# FMB140 Product Change Notifications

**Product change notifications (PCN)** is the way of informing customers of upcoming changes related to Teltonika products. This includes outward appearance adjustments, hardware improvements, firmware changes, changes to package contents, etc. This page stores information regarding changes to the FMB140 tracking device. Below you will find a list of both upcoming and already implemented changes sorted from newest to oldest (top to bottom).

**2021.04.16: Top Laser Printing Changes**

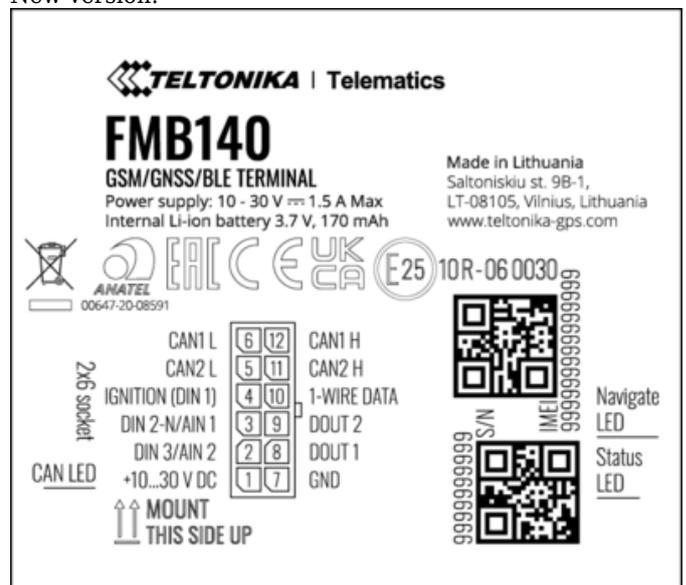
Change type External/visual  
Top laser printing design changed

Change reasons 1. Added ANATEL label and certificate number.
